**DEP FILE E04-369**  
**Falcon Ethane Pipeline System**  
**Response to Technical Deficiency Letter — Beaver County**

On behalf of Shell Pipeline Company LP (SPLC), AECOM Technical Services, Inc. (AECOM) has prepared the following responses to the PADEP comments dated June 1, 2018. AECOM is submitting two hard copies and two electronic copies of this comment/response letter and revised documents for the Falcon Ethane Pipeline System (Project) per the discussion held with PADEP, SPLC, and AECOM on June 1, 2018. Please add/replace these documents in your existing hard copies. Per previous discussion with Josh Shaffer at the Army Corps of Engineers (Corps) and with respect to the Corps' effort to reduce paper, the Corps' copy of this comment/response letter will be uploaded to the Corps' SAFE file upload site. The technical deficiency letter, as requested, is included with this submission as Attachment A.

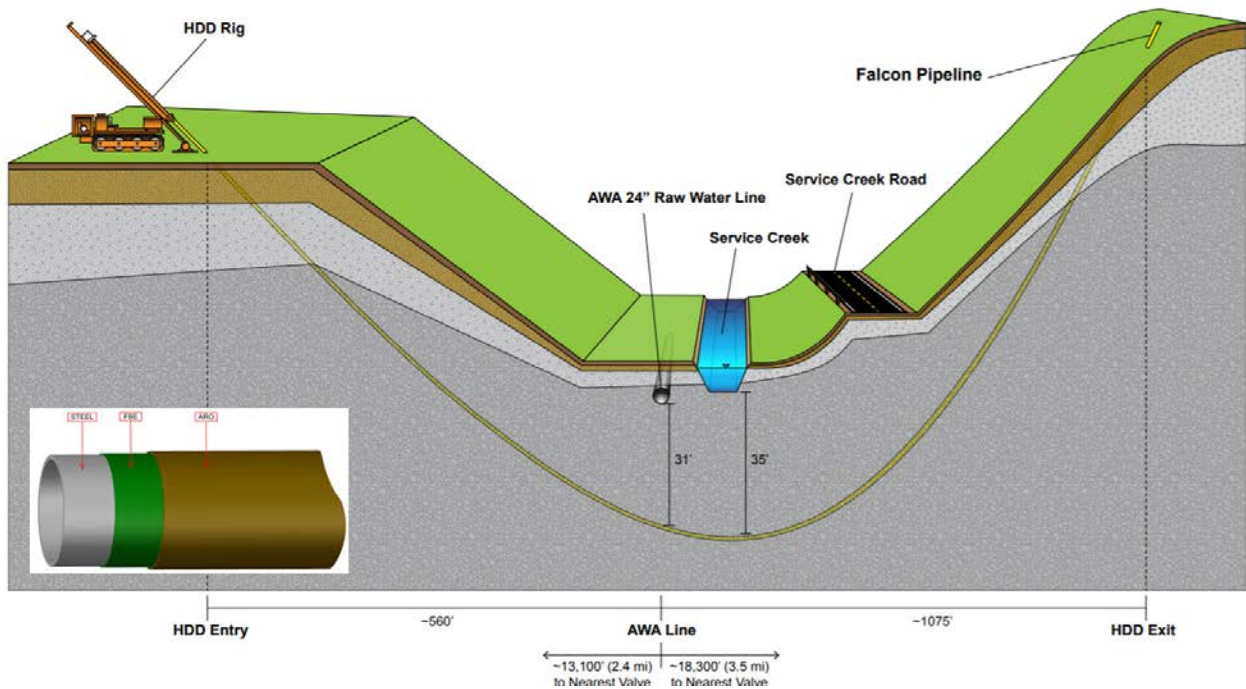
12. *Related to the preceding item, the Department has received multiple public comments, with concerns about your project's potential to affect the Ambridge Reservoir and the associated raw water service pipeline. Accordingly, evaluate and discuss your project's potential to affect the Ambridge Reservoir and to interrupt public water supply service, pursuant to Section 105.14(b)(5), of the Department's Chapter 105 rules and regulations. Based upon this evaluation,*

*discuss efforts to avoid and minimize impacts to this reservoir and/or public water system, and measures that will be implemented to mitigate for any unavoidable impacts, pursuant to Sections 105.13(e)(I)(viii & ix) and 105.14(b)(5), of the Department's Chapter 105 rules and regulations. You should to contact the Ambridge Water Authority to facilitate your response to this item.*

**Meetings were held between the Ambridge Water Authority (AWA) and the SPLC Falcon Team February 12, 2018, February 20, June 22, 2018, and July 13, 2018. Additionally, several email correspondences transpired, and a member of the Falcon team attended the monthly Ambridge Reservoir public board meetings.**

**The Ambridge Reservoir provides water to approximately 30,000 residents. A raw water line, comprised of pre-stressed concrete, is the only water supply from the reservoir. Several pipelines currently cross either the reservoir itself or the raw water line, as depicted in the figure in Attachment I. SPLC approached AWA to determine if SPLC could incorporate AWA's emergency response plan into the Falcon emergency response. Through discussions, it was discovered that AWA did not have an emergency response plan for the raw water line and the emergency response plan for the reservoir was related to flooding events and when to evacuate residents in the event of a major flood at the reservoir. The AWA was not concerned about the Project impacting the reservoir itself being that the Project was not crossing it. AWA was concerned about two issues with respect to the Project crossing the raw water line: (1) what could happen during construction and (2) what could happen following construction. AWA was most concerned about what could happen following construction.**

**During Construction: The HDD was designed to be 31 feet below the raw water line, as shown in the detail below. This is significantly deeper than the other adjacent pipelines. Geotechnical investigations which included soil borings were conducted within this area. SPLC retained a geotechnical expert to review the soil boring information and concluded that the silt and sand characteristics present around the raw water line will dampen any vibrations during construction, thus protecting the concrete water pipe during construction. The drill will be through competent bedrock, which should eliminate any settling issues.**

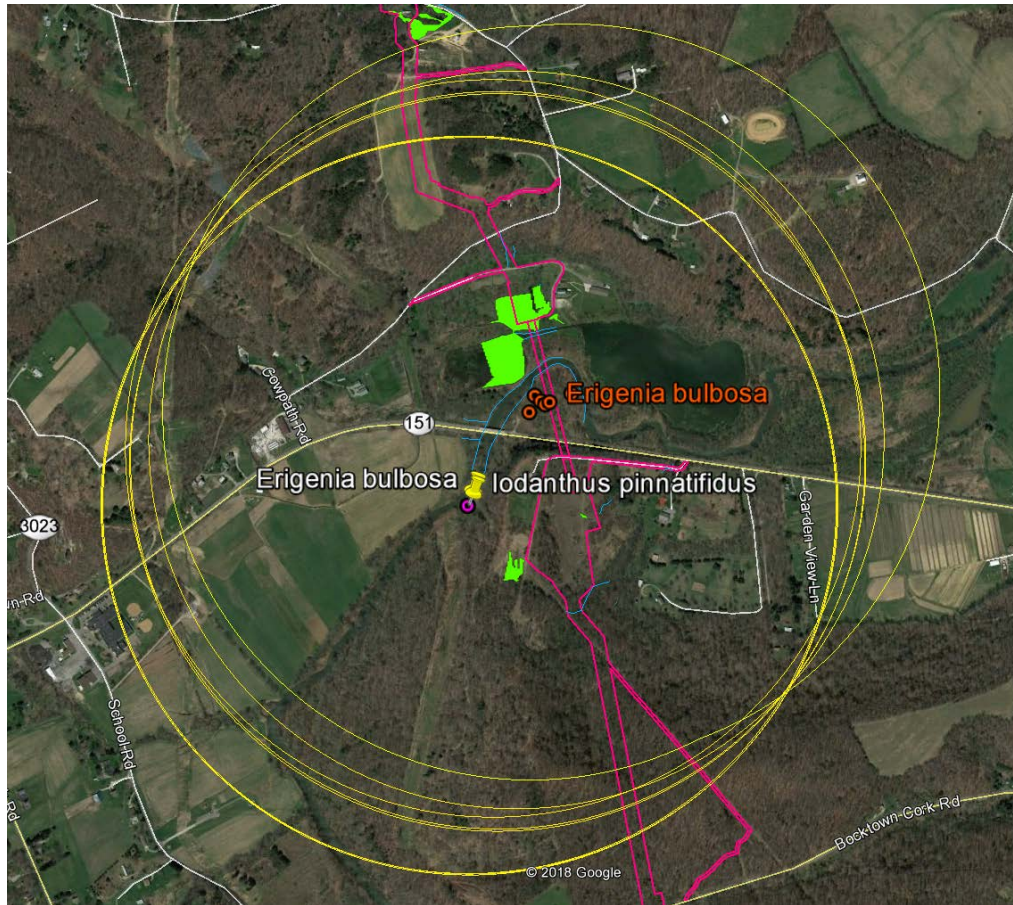
21. *Since Harbinger-of-spring (PA-threatened plant) and Purple Rocket (PA-endangered plant) were located within the Raccoon Creek floodplain, re-evaluate whether any of the identified wetlands within the project area are Exceptional Value (EV), pursuant to Sections 105.13(e)(1)(x)(B) and 105.17(1)(i and ii), of the Department's Chapter 105 rules and regulations. If any EV wetlands are identified within your project area, identify and quantify any impacts to these EV wetlands, and demonstrate compliance with the requirements in Section 105.18a(a)(1-7), of the Department's rules and regulations, regarding the permitting of structures and activities in EV wetlands.*

To properly identify EV wetlands, a one-half-mile buffer was drawn around each of the identified plant populations. Four PEM wetlands (W-PA-151014-MRK-001, W-PA-151013-MRK-002, 003, and 004), one PEM/PSS (W-PA-170407-JLK-001), and a PEM/PSS/PFO wetland complex (W-PA-151013-MRK-001) were all delineated within the 300-foot-wide study area located within the half-mile buffer. Additionally, it should be noted that the wetland complex delineated within the Beaver County Conservation District property is part of a larger complex that can be seen on aerial mapping. It was not completely delineated as it was outside of the 300-foot-wide study corridor.

To be considered an EV wetland, the wetland must serve as habitat for any threatened or endangered species. *Erigenia bulbosa* is not listed on the Eastern Mountains and Piedmont or on the National Wetland Plant List, which means it is considered an upland (UPL) plant species and not dependent on wetland habitat for survival. The populations observed in 2016 were in an upland area where *Fallopia sachalinensis* (giant knotweed, UPL) is the dominant species throughout most of the year. The population observed in 2017 was located within a disturbed upland area comprised of a mixture of UPL and facultative upland and wetland plants. Given *E. bulbosa*'s UPL status, and its occurrence within upland habitats not dependent upon or hydrologically connected to any wetlands, SPLC, through AECOM, has determined that its presence does not cause any of the wetlands within its vicinity to be EV. This is because *E. bulbosa* does not rely on wetlands for habitat, as understood by its classification as UPL.

*Iodanthus pinnatifidus* is listed as FACW in the Eastern Mountains and Piedmont Regional Plant List; however, The Plants of Pennsylvania lists the habitat for this plant as "moist alluvial woods and wooded slopes." Although it is FACW, this plant is not one that occurs in wetlands. The population observed in 2017 occurred within the same location as the 2017 *E. bulbosa* population, which was a disturbed upland area, comprised of a mixture of UPL and facultative upland and wetland plants. Given *I. pinnatifidus*' typical occurrence in uplands, and its occurrence within upland habitats not hydrologically connected to any wetlands in this Project, AECOM has determined that its presence does not cause any of the wetlands within its vicinity to be EV.

Please refer to the screenshot below for a pictorial representation of the analysis. The yellow circles represent the buffers around each of the observed plant locations, the green polygons are wetlands, blue lines are streams, and the pink line is the Falcon LOD.

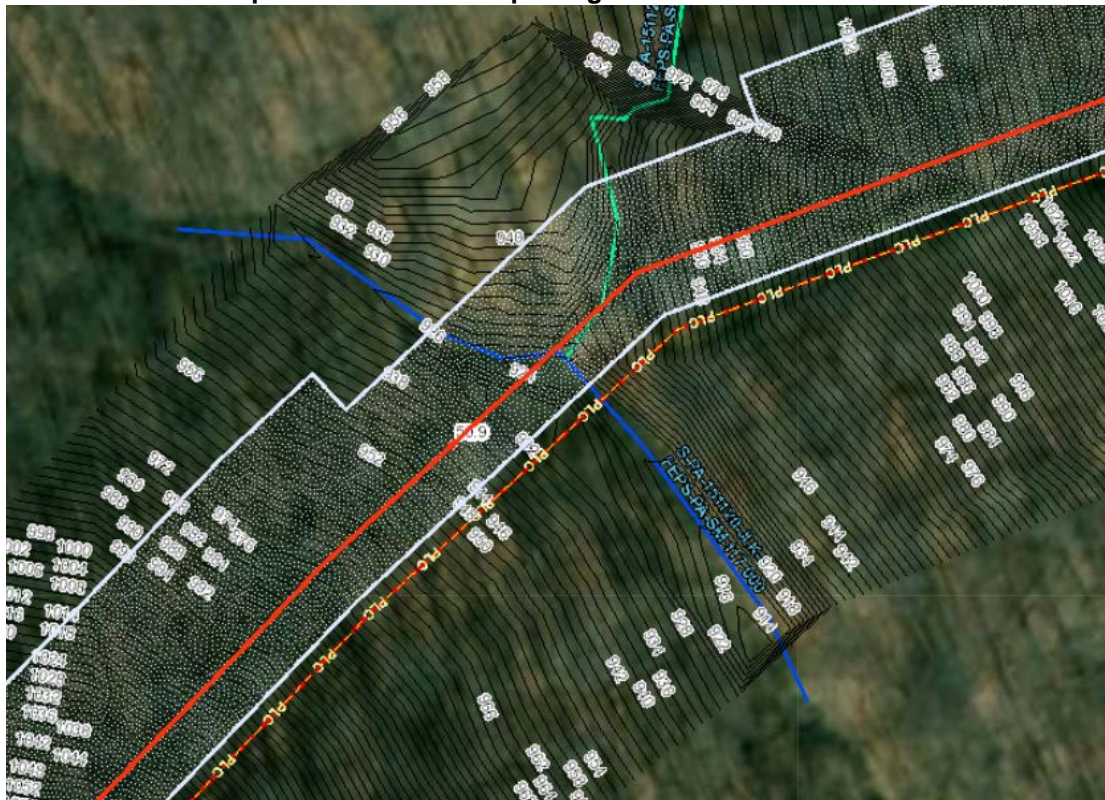
- d. *Revise Plan View Map, Sheet 13 of 54 to include W-PA-161220-MRK-007 at/near RC- 22. Sheet 13 of 54 has been revised to include W-PA-161220-MRK-007. The revised Plan View Map is included as Attachment C.*

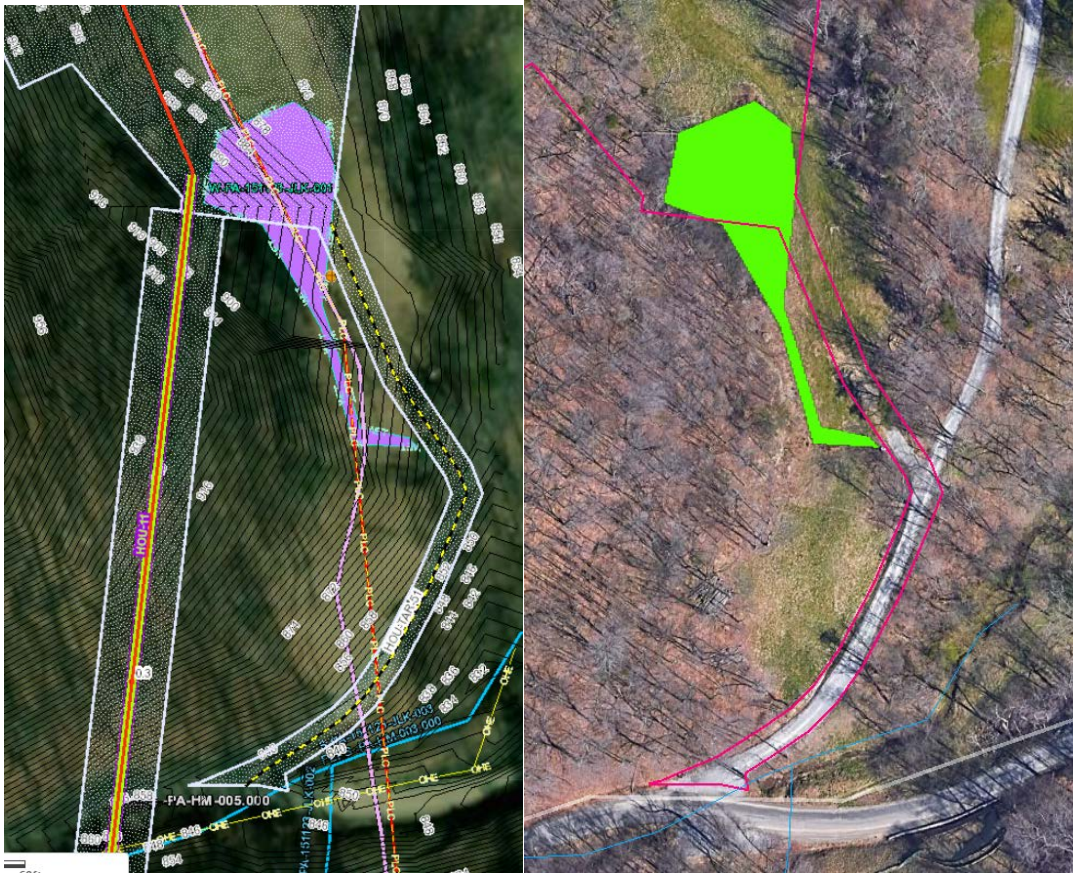
HOU-TAR-50 was originally added to the permit because the majority of SCIO-PAR-09 is the landowner's driveway and the landowner did not want heavy equipment on his driveway because it would damage the driveway. SCIO-PAR-09 was to be utilized to take small equipment/trucks to the junction site while HOU-TAR-50 was to take large equipment to the Project area.

After receiving this comment, the SPLC Land group went to the landowner to negotiate removing HOU-TAR-50. The landowner agreed, however, SPLC has added a small access road (SCIO-TAR-39) that follows an existing logging road from SCIO-PAR-09 to the LOD around Scio MP 51.2, as seen in the screenshot below.

This new access road was located within an area that had been previously delineated and contained no resources. Additional cultural resources work needed to be done however to clear the area. The revised plan view mapping is provided in Attachment C and the ESCGP-2 drawings have also been revised to reflect this change and are included with this response to comment package.

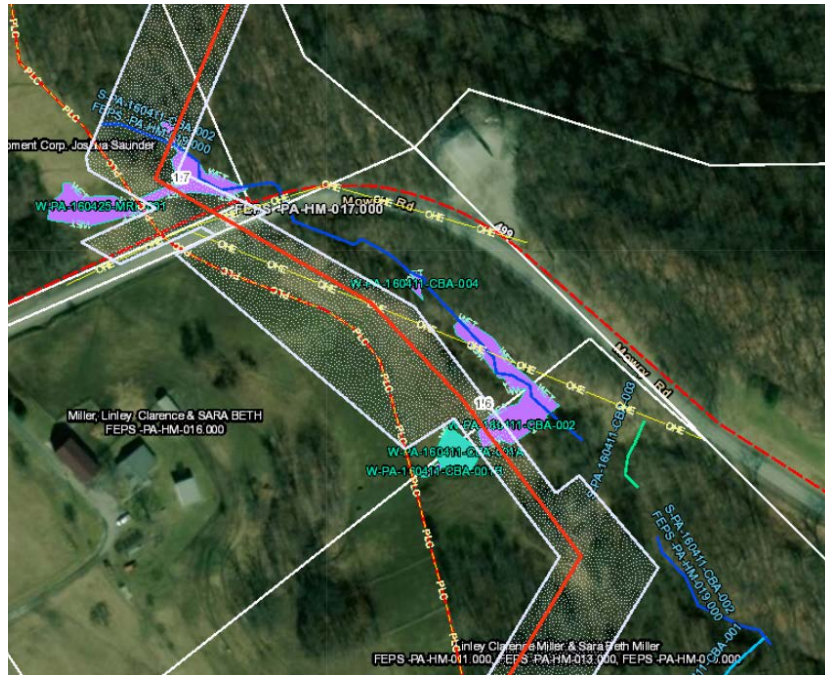
- i. *Adjusting route to avoid or minimize impacts at RC-48 to -50.*  
The LOD was narrowed along the route here to reduce the impact. A “three-joint drag section” method will be utilized for constructing in such a narrow corridor. This is not a desirable construction method because it is essentially a travel lane and not a full construction corridor. The centerline could not be shifted further away from the stream due to the location of the Sunoco pipeline (red and yellow dashed line in screen shot below). Also, an overhead electric line (yellow line) was present and electric companies have specific stipulations as to where a pipeline can be located with respect to their ROW and their power poles. The revised plan view mapping is provided in Attachment C, the revised impact table is included as Attachment D, and revised site-specific drawings are included as Attachment L. Revised E&S drawings are provided in the updated E&SCP included with this response to comments package.

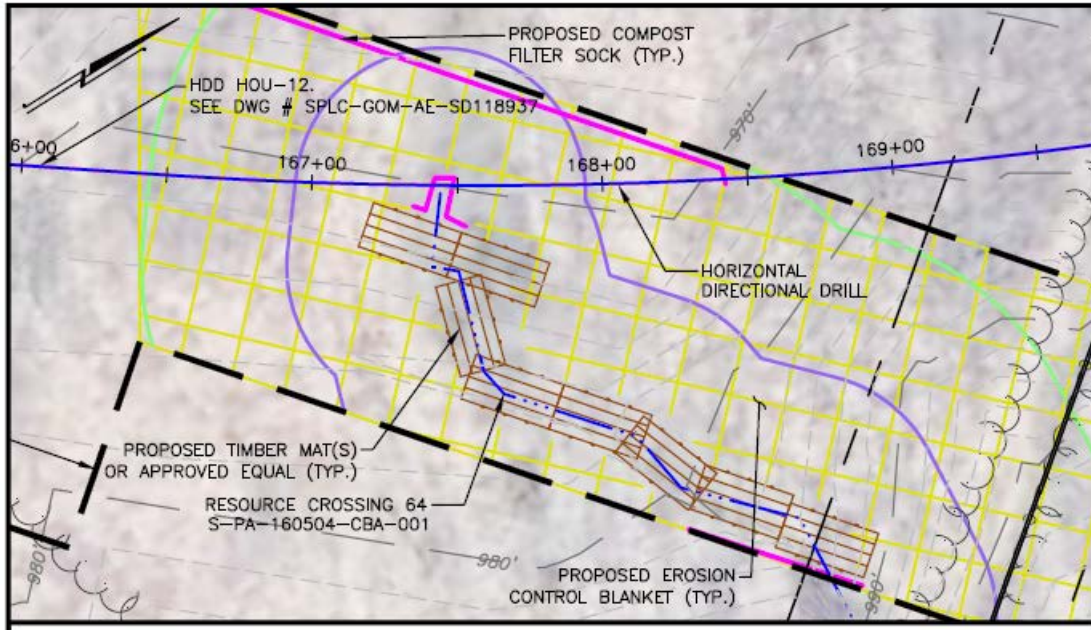
- k. *Reducing impacts to S-PA-160504-CBA-001 at RC-64.*  
**S-PA-160504-CBA-001 is located within the pullback area for HDD HOU-12 (see first screenshot below), which is the HDD across Raccoon Creek. Given the very steep slope and location of HDD HOU-13 (which is the entrance to the Plant) this was the only feasible location for this HDD. The stream will not be open-trenched in this area. The impact will be due to the timber mats placed on top of the stream to prevent equipment from entering the stream. The large floodway impact is due to the erosion control blanket that is placed in the upland area within this workspace. These impacts can be seen on the site-specific drawing for RC-64. A screenshot of this drawing is also provided below. Impacts to the S-PA-160504-CBA-001 and its floodway are already minimized to the greatest extent practicable by covering the watercourse with timber matting and minimizing erosion in the floodway area.**

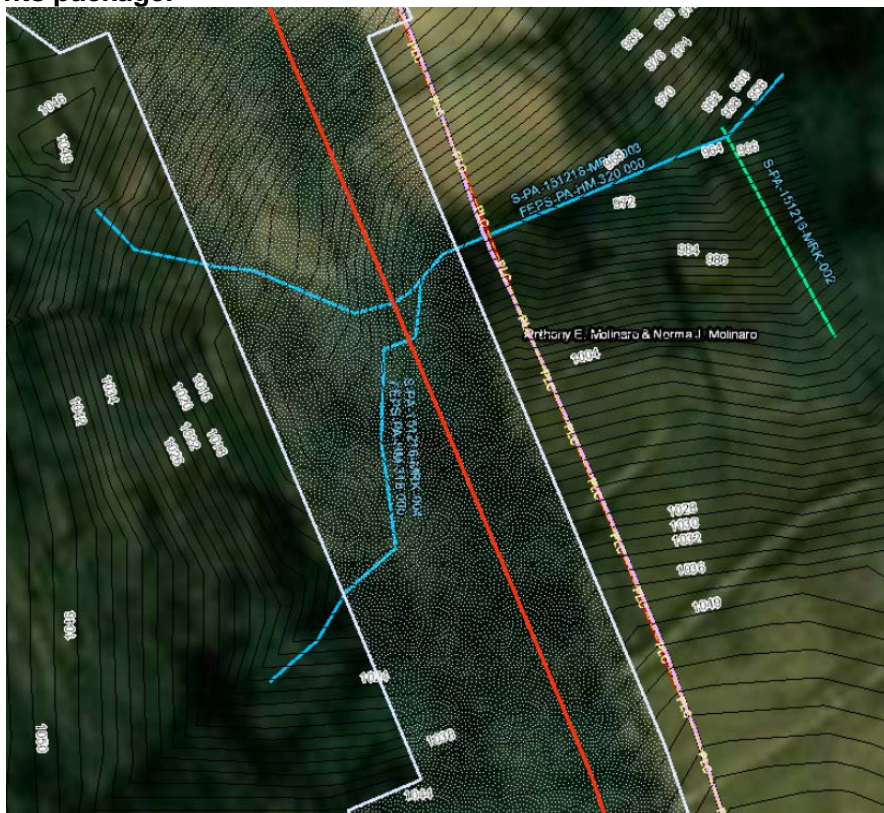
n. *Moving valve site from S-PA-151013-MRK-004 at RC-75.*

It has been determined that S-PA-151013-MRK-004 is no longer a watercourse because it no longer has a hydrology source. The watercourse was originally formed when a culvert became damaged along Cowpath Road, upslope of the Beaver County Conservation District BCCD property. Over time, runoff from the road flowed down the slope onto BCCD property because it could not flow down Cowpath Road due to the broken culvert. The water carved a drainage with sufficient bed and bank that the AECOM wetland scientists delineated it as an ephemeral watercourse.

The BCCD informed the PADEP, USACE, and Falcon team during the site visit on May 15, 2018 that the watercourse was not always there and had been formed because of the broken culvert. BCCD suggested that the team contact Independence Township for further information. The township was contacted, and the municipal clerk stated that on July 10, 2017 the Independence Township Road Department added 15 feet of 18-inch culvert to Cowpath Road to fix the drainage problem. As a result, this channel is no longer receiving hydrology. Given that, it was reclassified as an upland swale. As a result, the valve site does not need to be removed because it is no longer causing a fill. The revised plan view mapping is provided in Attachment C, the revised impact table is included as Attachment D, and revised site-specific drawings are included as Attachment L. Revised E&S drawings are provided in the updated E&SCP included with this response to comments package.

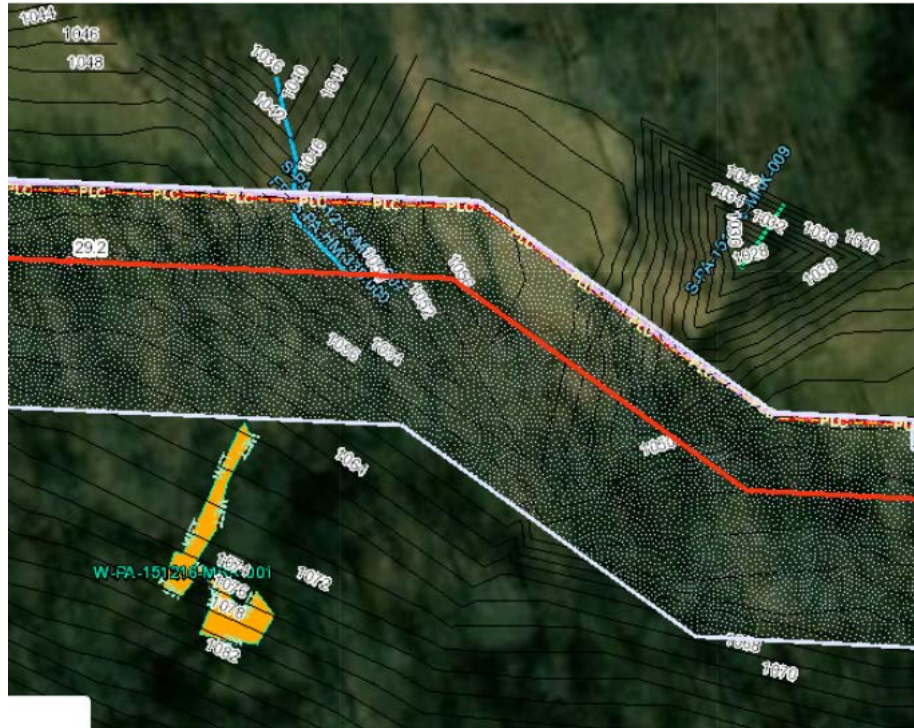
r. *Adjusting route to avoid impacts at RC-91 and-92.*  
**The Project is also paralleling the two Sunoco pipeline Sunoco and Mariner West ROW in this location (see screenshot below). As a result, the Project cannot shift further northeast due to the risk of exposing either line to side slope issues and to avoid**

crisscrossing the pipelines. Shifting the line to the south would impact a PSS wetland. The LOD cannot be notched in to avoid 19ft<sup>2</sup> floodway impact to S-PA-151216-MRK-009 because that is the pipe side of the ROW and that workspace is necessary for construction.

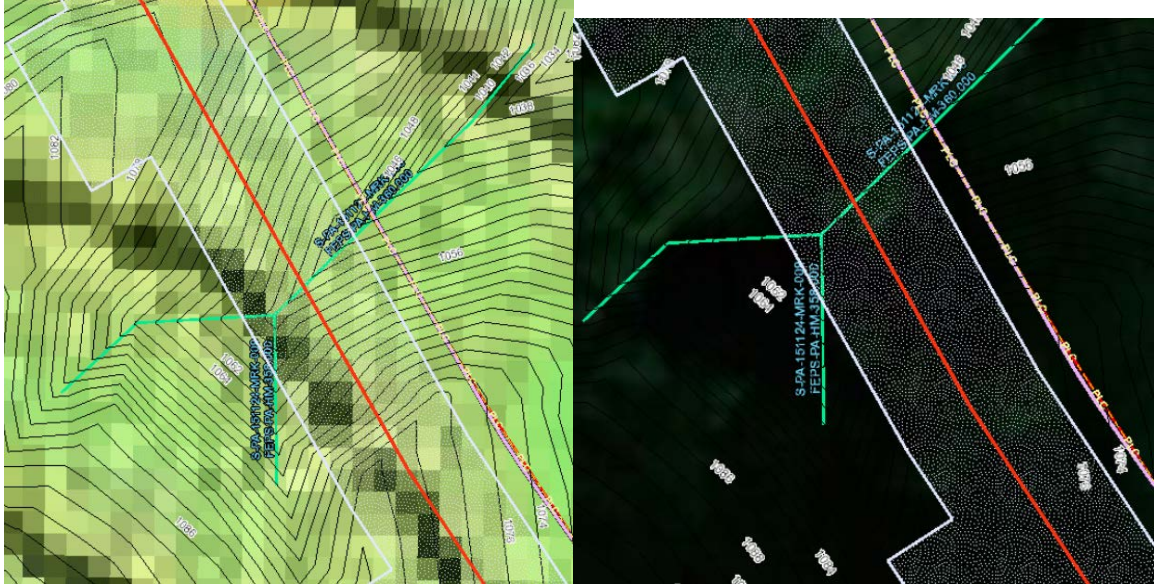
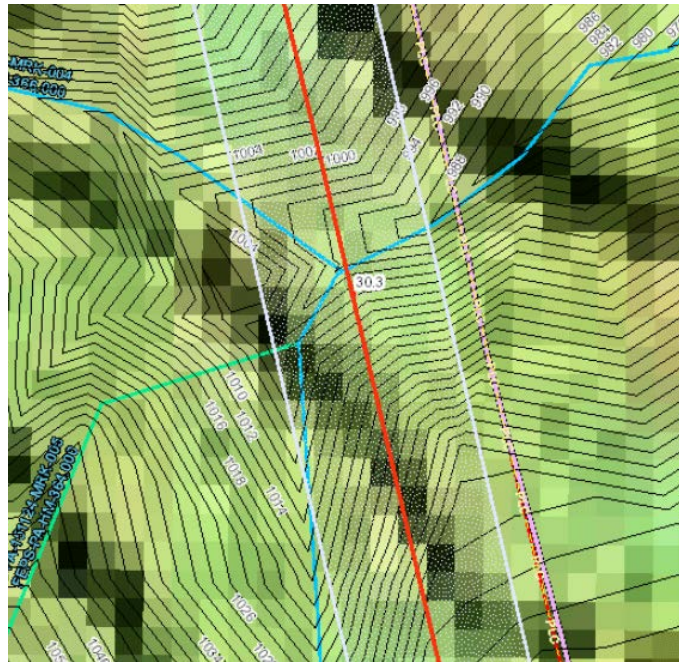
- u. *Adjusting route away from confluence of streams at RC-101.*

Again, the Project is routed along the Mariner West and Sunoco line, as seen in the screenshots below. The route here however was not as steep in as in some of the previous locations so the LOD was able to be reduced to 50 feet and a four-joint drag section will be employed during construction. This is typically not ideal as it reduces the construction ROW to essentially a travel lane, however, in certain circumstances it can be accomplished safely. The revised plan view mapping is provided in Attachment C, the revised impact table is included as Attachment D, and revised site-specific drawings are included as Attachment L. Revised E&S drawings are provided in the updated E&SCP included with this response to comments package.
